From: BRYAN Martin (EXT) [Martin.Bryan.ext@areva.com]
Sent: Tuesday, May 25, 2010 6:22 PM
To: Tesfaye, Getachew
Cc: DELANO Karen V (AREVA NP INC); ROMINE Judy (AREVA NP INC); BENNETT Kathy A (OFR) (AREVA NP INC); HOLM Jerald S (EXT)
Subject: Response to U.S. EPR Design Certification Application RAI No. 241, FSAR Ch 15, Supplement 2
Attachments: RAI 241 Supplement 2 Response US EPR DC.pdf

Request for Additional Information No. 241, Supplement 2

U.S. EPR Standard Design Certification

Question 15.06.05-51:

Figure 15.06.05-51-1—Modeled Steam Flow Paths and Elevations

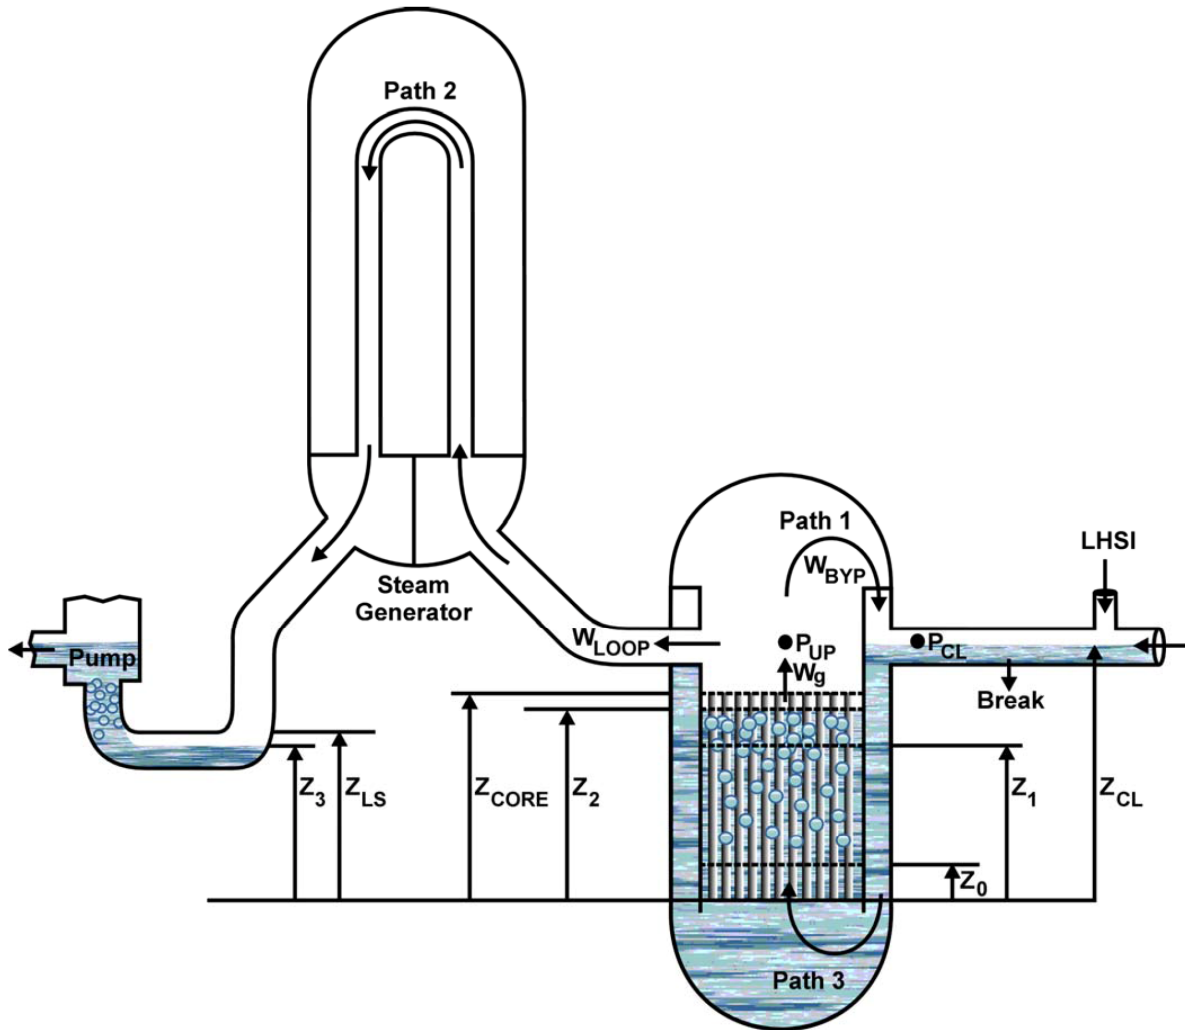
If the two-phase mixture level drops below the TAF anytime during the U.S. EPR long term cooling phase of a LOCA, cladding heatup and oxidation can result.

Please provide the results of a thermal-hydraulic analysis quantifying the two-phase mixture level within the reactor core barrel during the long term cooling of the U.S. EPR core under the most limiting break size, break location and ECCS performance conditions. Discuss the conservatism of the obtained results. For important modeling parameters that are expected to vary within a certain range, substantiate the conservatism in selecting the value for each parameter or provide sensitivity assessments over the expected range of variation.

Figure 15.06.05-51-1 shows the concept and essential features of the quasi-steady static-balance model. The assumptions and description are as follows:

- 1) The system is assumed to have reached a quiescent state without significant fluid dynamic effects.
- 2) Elevations are relative to the bottom of the active fuel. The TAF is at elevation Z_{CORE} . The top of the cross-over pipe U-bend (loop seal) is at elevation Z_{LS} . The water level in the loop seal piping, Z_3 , is shown below the elevation Z_{LS} to acknowledge possible depression of the water level during steam venting via the loop seal; however, details of the depression are not modeled. The water level Z_3 increases above Z_{LS} at low decay power when steam is not vented through the loop seal.

- 1) High decay power in the post-reflood period causes the steam generated within the active core to vent through Path 1 and Path 2 as shown in Figure 15.06.05-51-1. The depression of Z_3 below Z_{LS} is not accurately known; however, Z_3 approaches Z_{LS} as the steaming rate approaches the transition (see Item 2). The impact of the depression of Z_3 on Z_1 is also offset by a reduction in elevation head of the two-phase mixture in the vertical leg on the pump side of the loop seal that increases Z_1 . The Zuber-Finlay correlation ($Co=1.25$, V_{gj} constant = 1.41), as presented in Reference 2, is used to compute the void fraction in that vertical leg, which is not a critical choice. This is also a period when the high steaming rate causes significant level swell. Thus, the assumption of $Z_3 = Z_{LS}$ is an acceptable approximation for this period.
